W3F1-2021-0050

Subject: Response to U. S. Nuclear Regulatory Commission Request for Additional
Information Regarding License Amendment Request to Adopt
10 CFR 50.69

Waterford Steam Electric Station, Unit 3
NRC Docket No. 50-382
Renewed Facility Operating License No. NPF-38

Enclosure 1: Responses to APLA RAIs

Figure 2-3 - WF3 Seismic Response Spectra

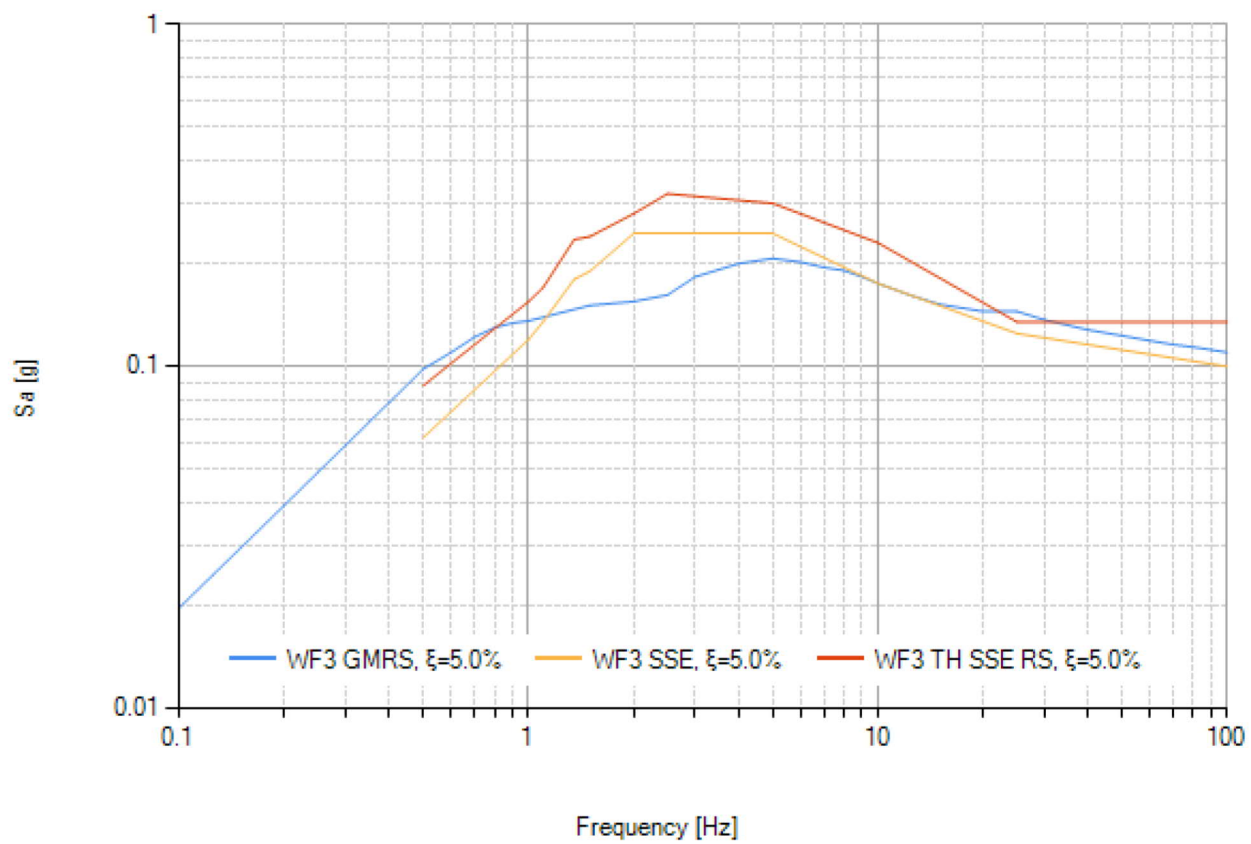
- a. Provide justification for a plant HCLPF capacity of 0.25g used for Waterford 3.
- b. Justify that the plant-specific seismic risk is low relative to the overall plant risk such that the categorization results will not be significantly impacted to support the applicability of the proposed alternative seismic approach to Waterford 3.

The WF3 SSE, SSE TH RS, and GMRS are plotted in Figure 2-3 with associated PGA values of 0.1g, 0.135g, and 0.11g respectively. The 2 - 8 Hz range is generally considered to be the most damaging for SSCs, and it

can be seen that the SSE TH RS exceeds the SSE, which in turn exceeds the GMRS across that frequency range. This implies an intrinsic level of seismic margin built into the design.
